REMARKS

AMENDMENT TO THE DRAWINGS

Fig. 4

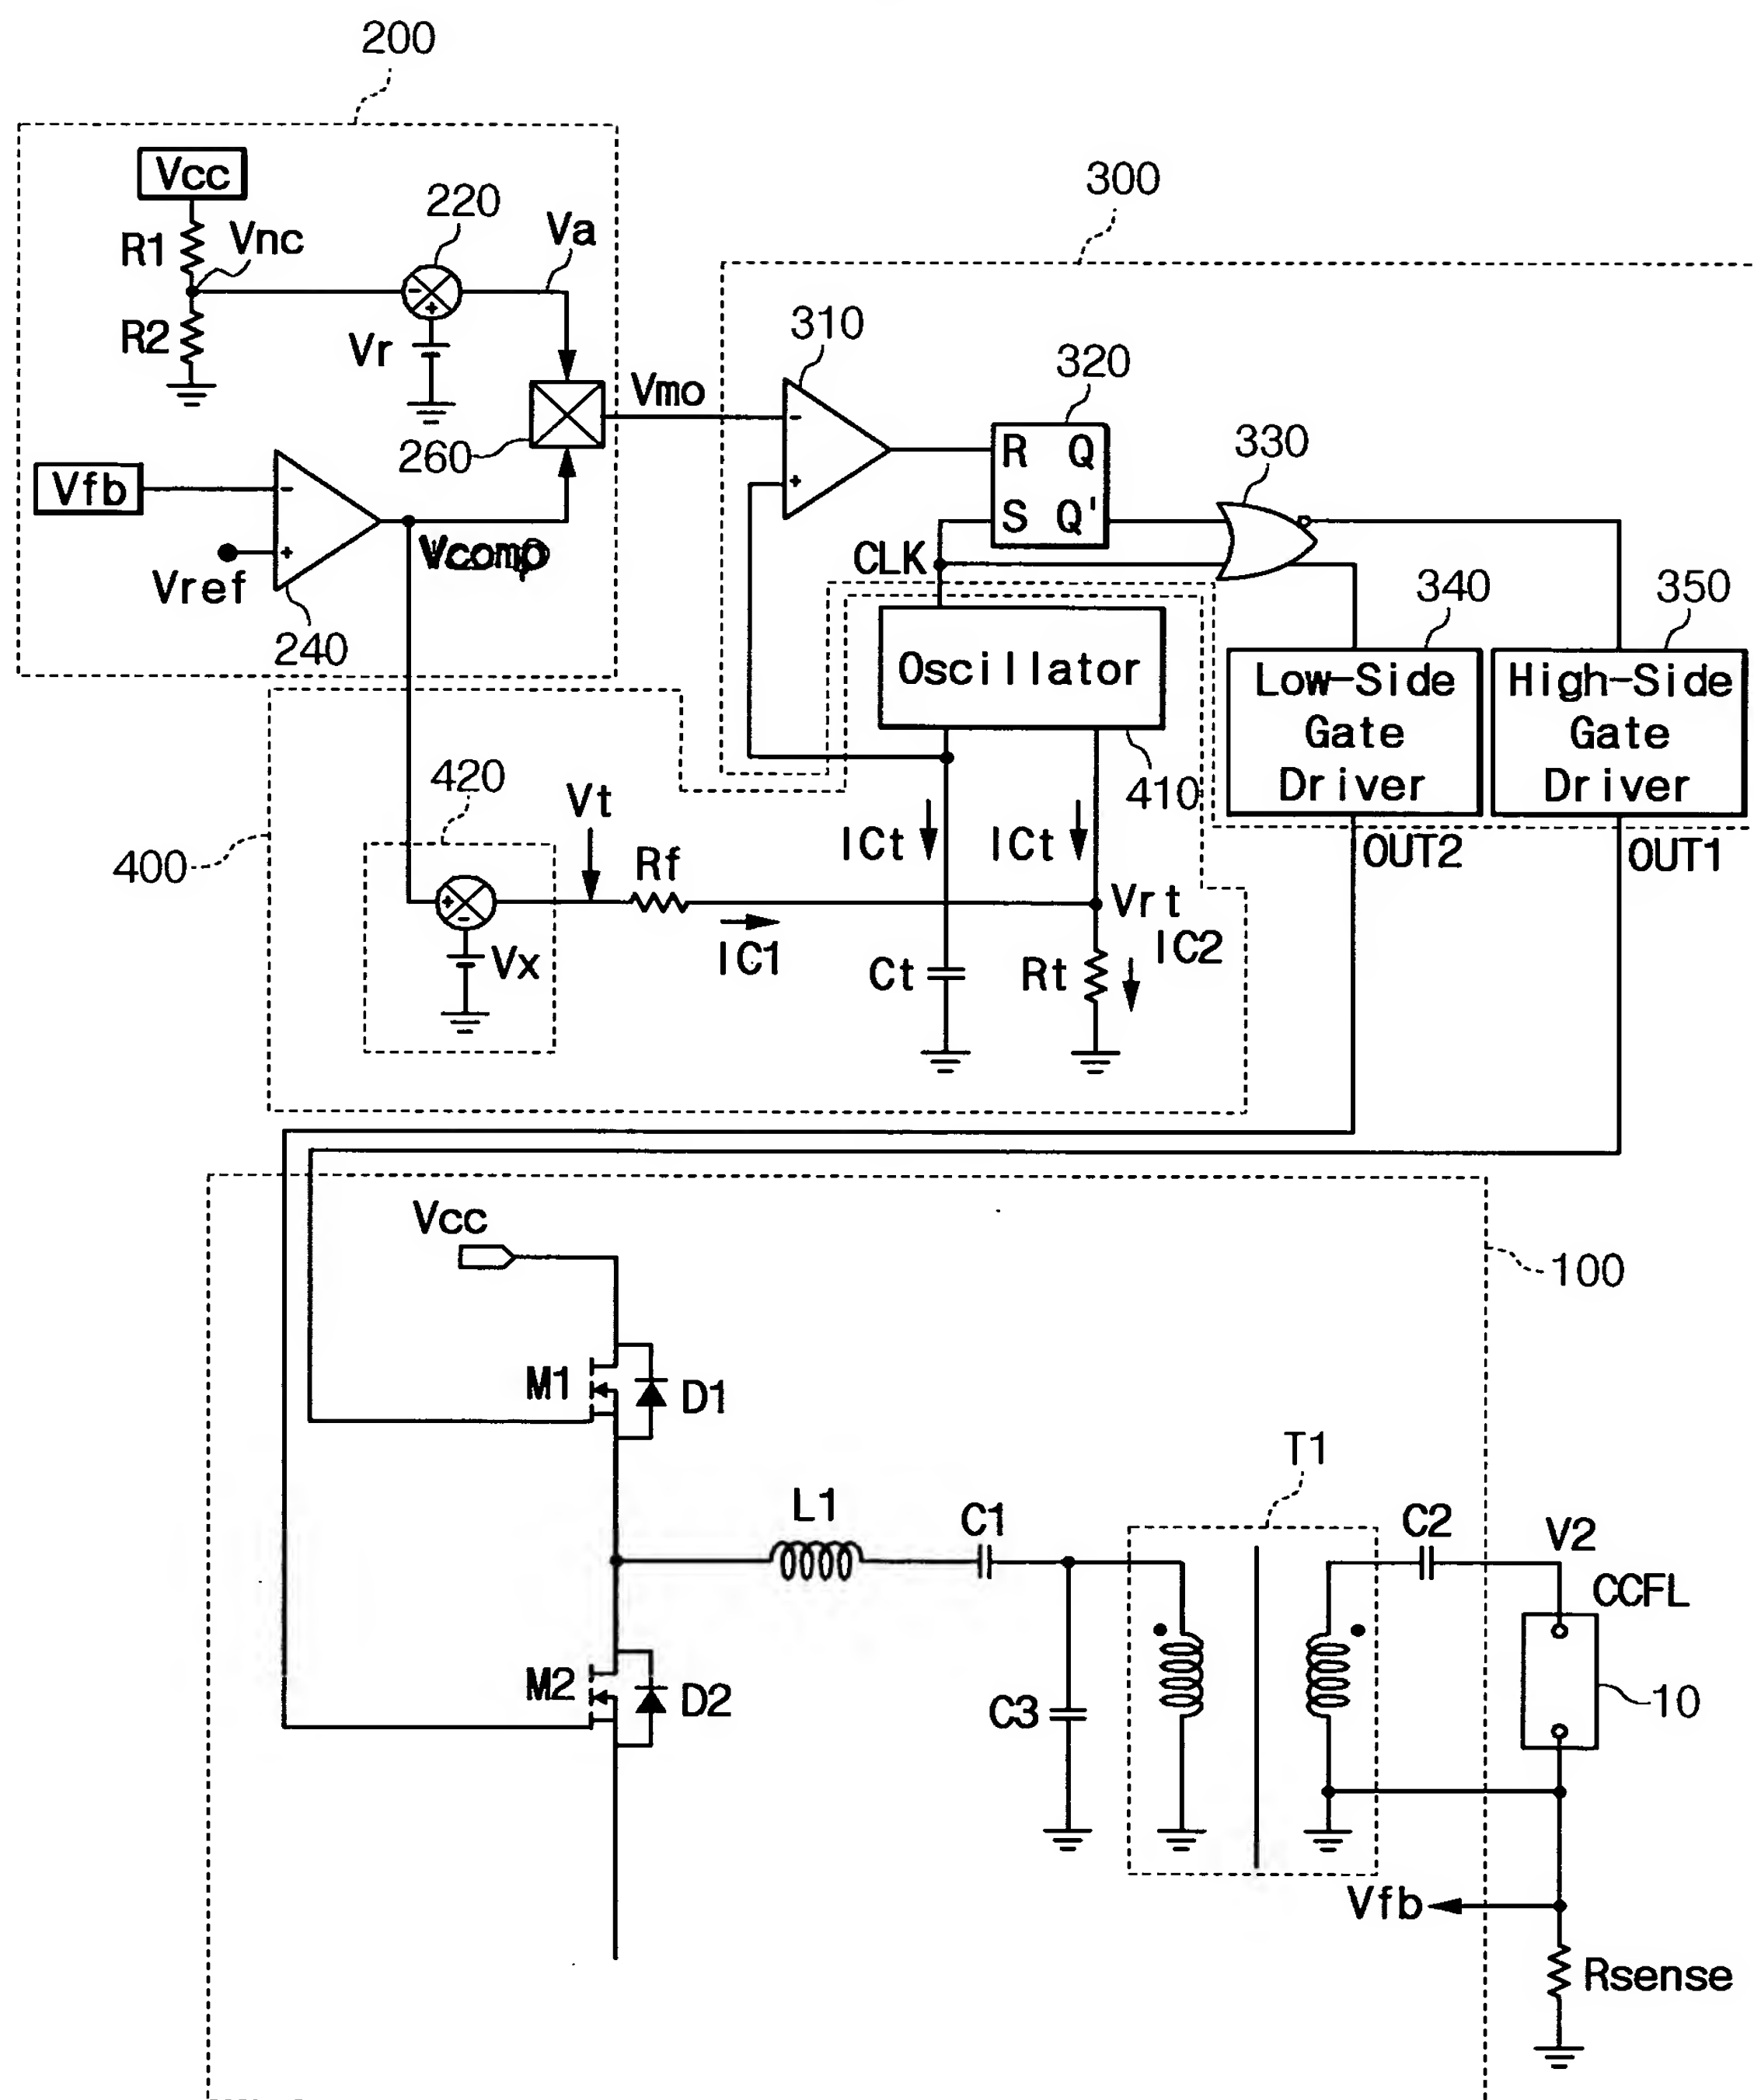
According to the Examiner, “no capacitor is seen in instant Fig. 3, although it is referred to in the specification at page 4 [para 0028]. Also, Fig. 4 is incorrect in that the input to amplifier 430 should be ‘Vcomp’ (not Vmo), see the specification at page 10 [para 0069]. Moreover, ‘Vcomp’ needs to be labelled in instant Fig. 1. Finally, it is not clear where in Fig. 1 the ‘amplifying means’ is referred to at page 5 [para 0031, line 6].”

The drawings are objected to because Fig. 1 and 4 had missing or incorrect components. Corrections have been made and amended Fig. 1 and 4 have been submitted with this Response.

Applicants have amended Figs. 1 and 4 of the drawings. In Fig. 1, a capacitor C3 which was not previously shown in the figure has been added. In addition, “Vcomp” is now labelled in Fig. 1. As for Fig. 4, the input amplifier 430 has been changed to “Vcomp.” Lastly, the “amplifying means” referred to is performed by comparator 240, which is described in paragraph 0031 of the Specification.
